DATSUN

Technical Bulletins

1979

Technical Bulletins

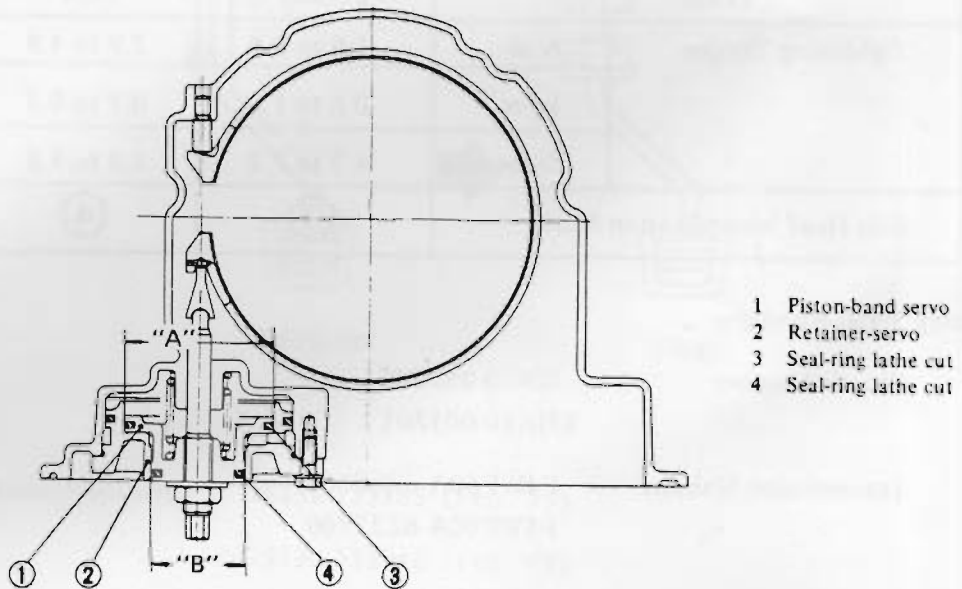
The speedometer pinion retaining bolt has been changed from 7T to 4T type. Along with this change the tightening torque has been revised as shown below.

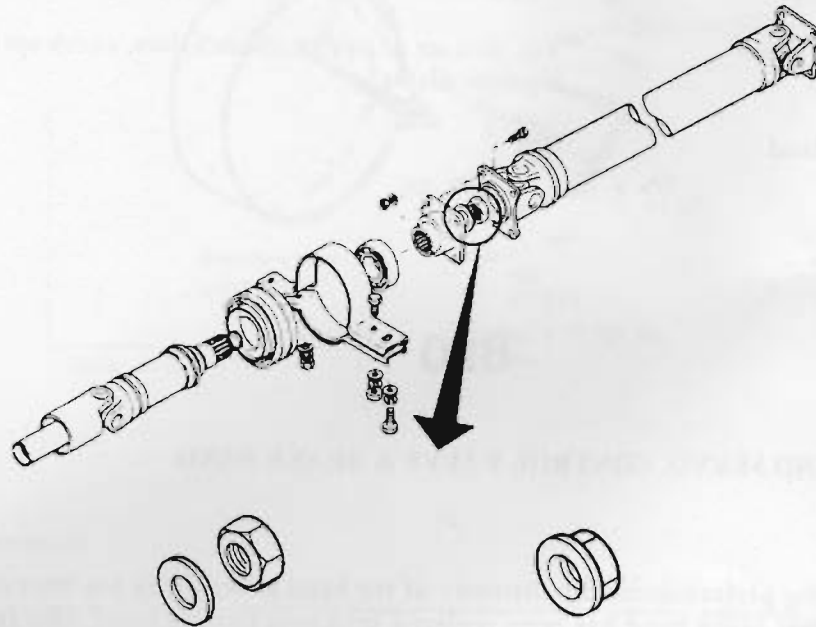
To improve shifting performance, the diameter of the band servo piston has been decreased and the former rigid brake band has been replaced by a new flexible band. Also the orifice check valves, in the control valve assembly, have been redesigned. For a complete description with illustrations and parts information, see 510-004, on page 2.

200SX-002

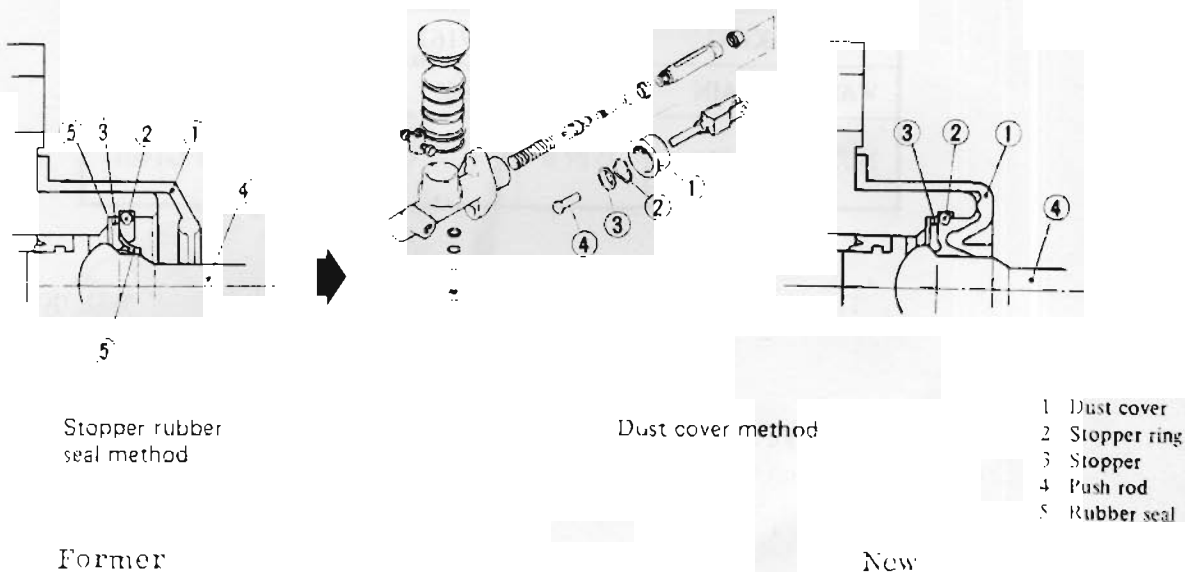
To simplify servicing, the method of sealing the clutch master cylinder has been changed. It is now sealed by the dust cover rather than the stopper's rubber seals. In the new cylinder design, the dust cover has been redesigned and the stopper's rubber seals have been eliminated.

Separate plate

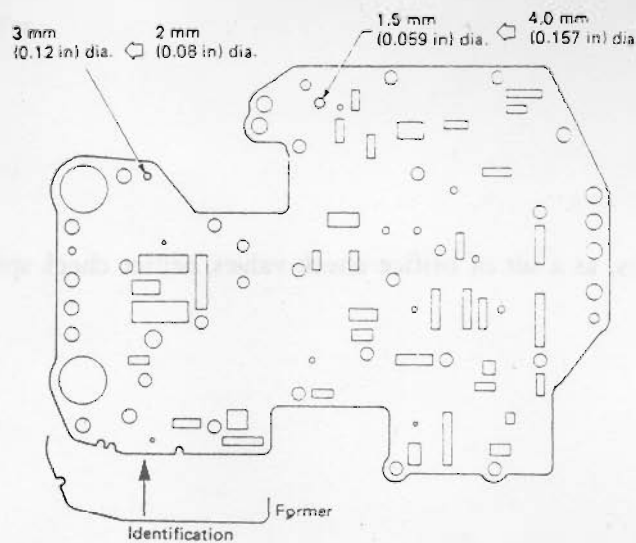
To improve shifting performance, an orifice check valve (on the release side of the band servo) has been added and the bore diameter of the orifice check valve (for 2-3 shift) has been decreased. Also, the bore diameters of the separate plate (on the release side of the band servo and the apply side) have been decreased.
